SUBJECT: Class II Permissive change

This is to request a Class II permissive change as following FCC ID.

FCC ID: MMALXT600PA

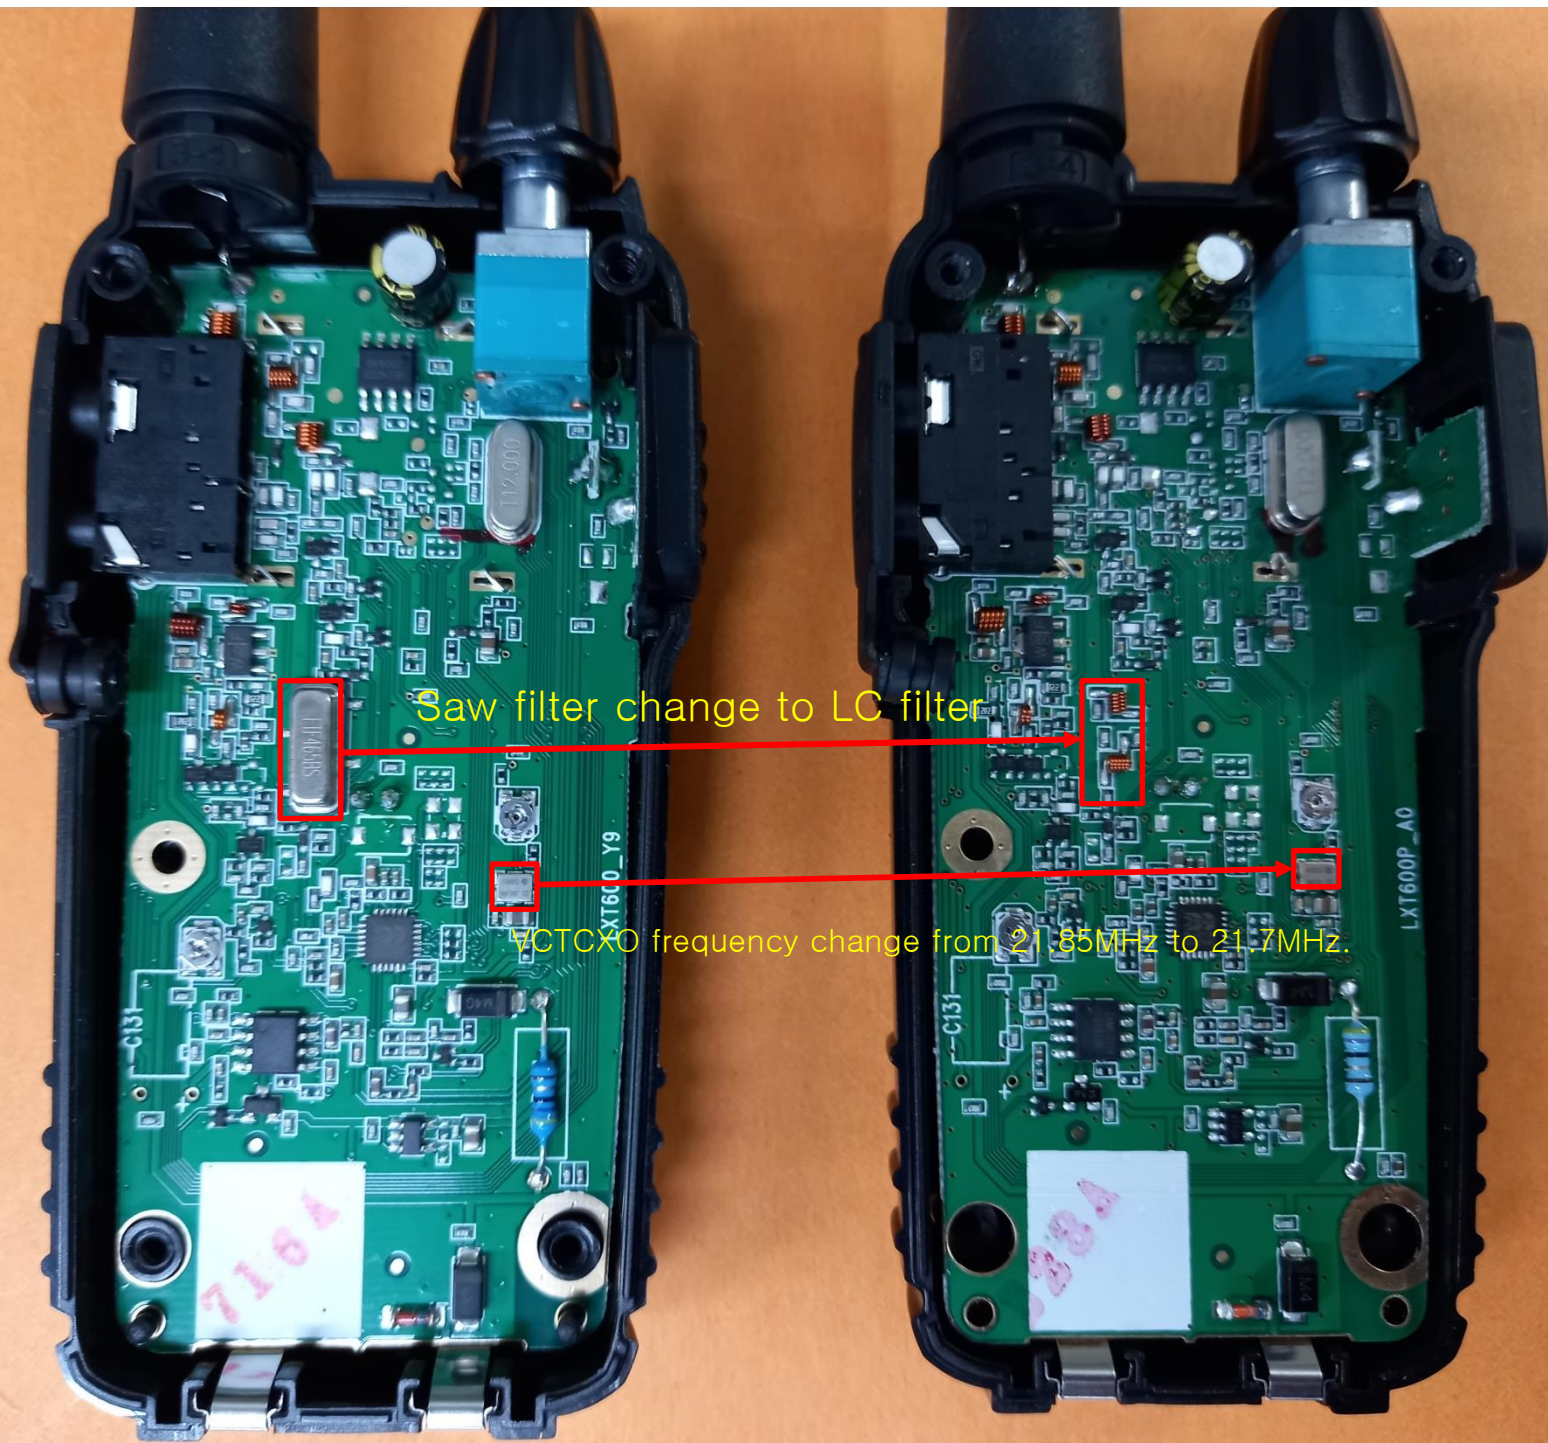
- 1) SF1(FTF465BS) of Saw filter change to Y12 LC filter(C69, C71, C72, C75, L16, L19)
- 2) TCXO1(21.85MHz) only change frequency to 21.7MHz.

Saw filter change to LC filter

VCTCXO frequency change from 21.85MHz to 21.7MHz.
